Subject: Important information regarding the safety of Monnal T60 ventilators
SWISSMEDIC Ref: Vk_20230111_03

This corrective action involves updating all devices in the Monnal T60 range placed on the market, by deploying the software versions listed below, as well as providing a new associated user manual (UM):

- Monnal T60 range: software version V2.8.x
- Monnal T60 Advanced range software version V1.2.x

Situation 1: Possibility of having an Fio2 setpoint applied that is different to the setpoint displayed after using the 100% O2 function.

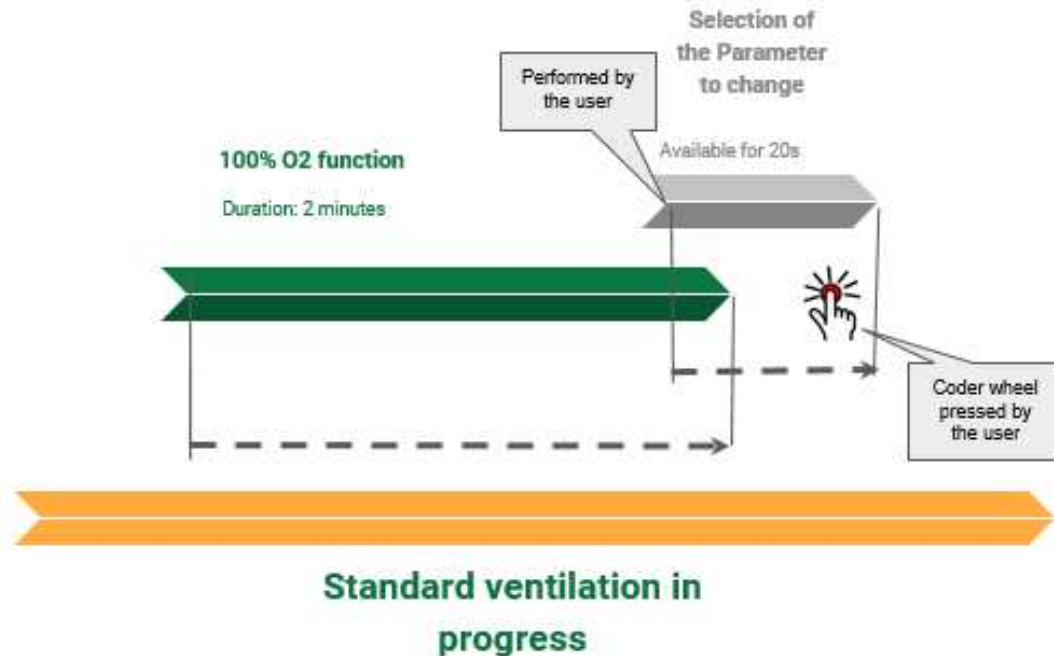
Description of the problem: If the user wants to change the FIO2 setpoint a few seconds before the end of the two-minute period of the 100% O2 function, and this setpoint was confirmed just after the end of the 100% O2 function (see graph below), this can cause a conflict between the setpoint applied and its display.

The risk is that the applied Fio2 level is higher than the displayed setpoint, posing a risk of hyperoxia, or lower than the setpoint, posing a risk of hypoxia.

Air Liquide Medical has introduced a software correction that will prevent any "Awaiting confirmation" parameter from being maintained after the 100% O2 function two-minute period.
